**YEAR 4 MONITORING REPORT**

**ROSES CREEK STREAM MITIGATION SITE**  
Burke County, North Carolina  
NC DMS Project # 96309

RE: NCDEQ – Division of Mitigation Services  
Roses Creek MY 4 Monitoring Report  
DMS Project Number: 96309  
Response to DMS Review Comments on Draft Year 4 Monitoring Report for Roses Creek

**Appendix D. IRT Meeting Minutes (08/27/2019)**

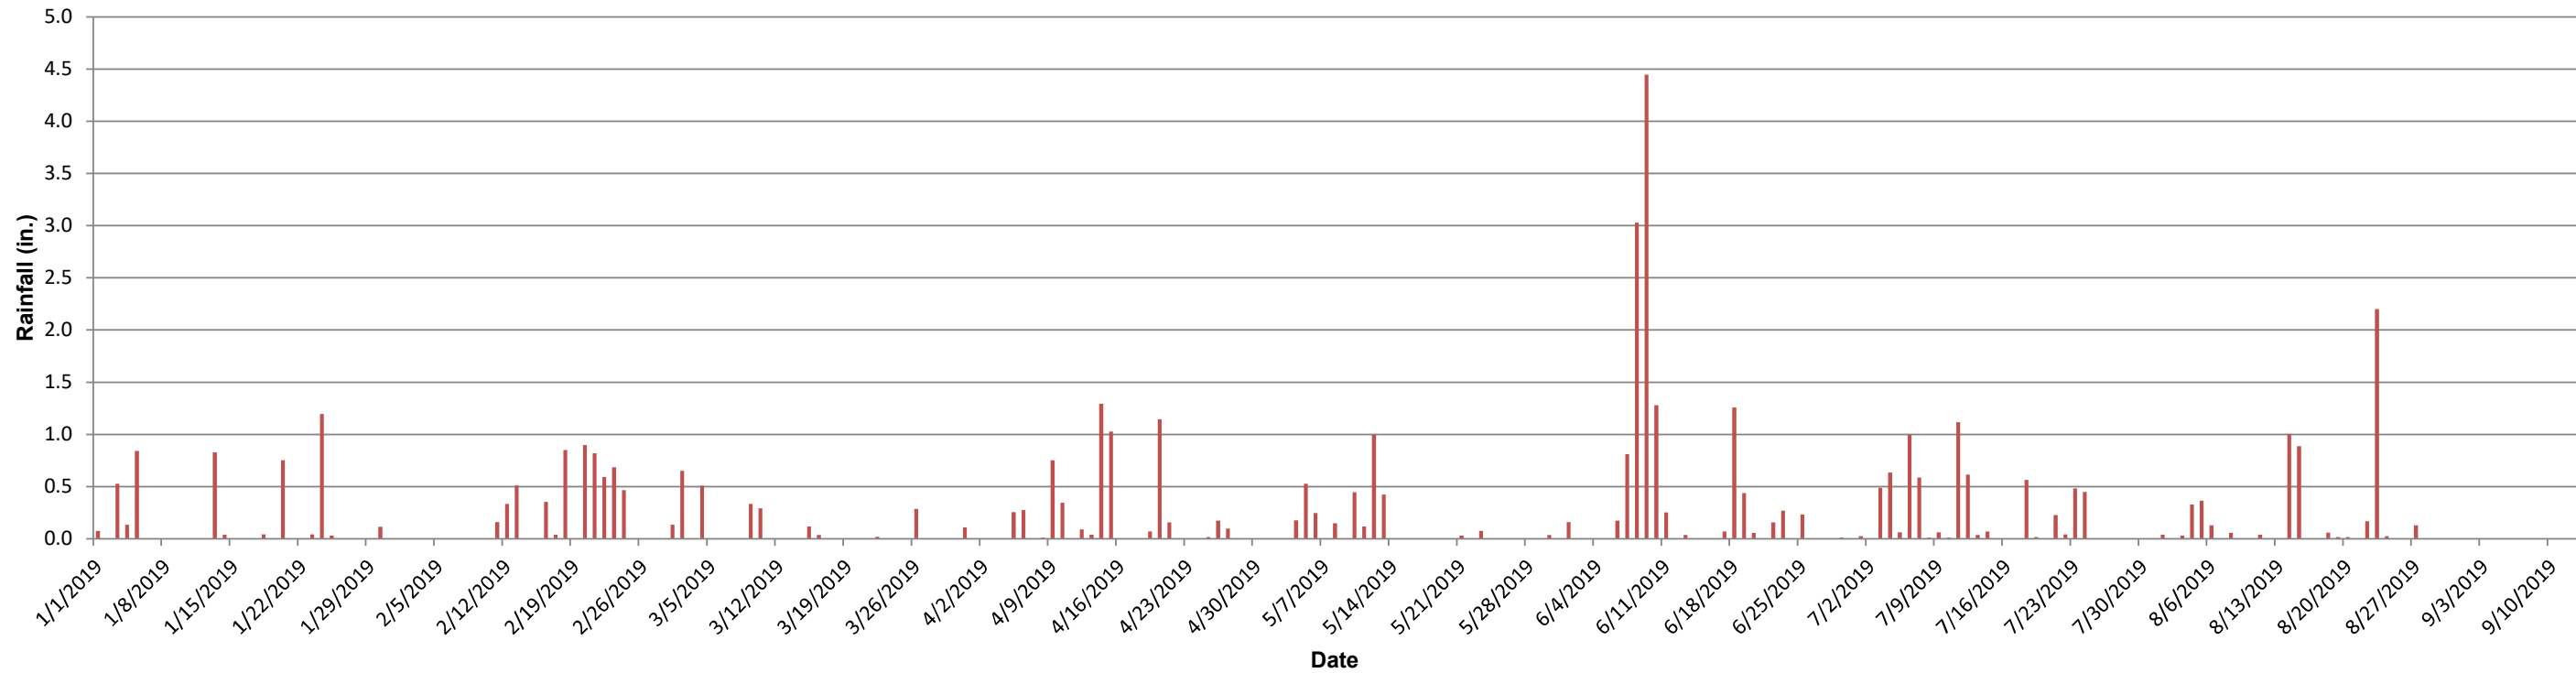
4. Fig 5.3 x-axis label has distance rather than time as a label.

6. Surface Water Level Meter Data – If available, rain data should be shown concurrently, with the most consecutive days/dates during which criteria were met.

*Response: The x-axis label has been corrected and Figure numbers for the Figure 5 series were changed to Figure 4 series to match figure numbering in the MY4 report.*

*Response: Rain data has been added to Surface Water Level figures.*
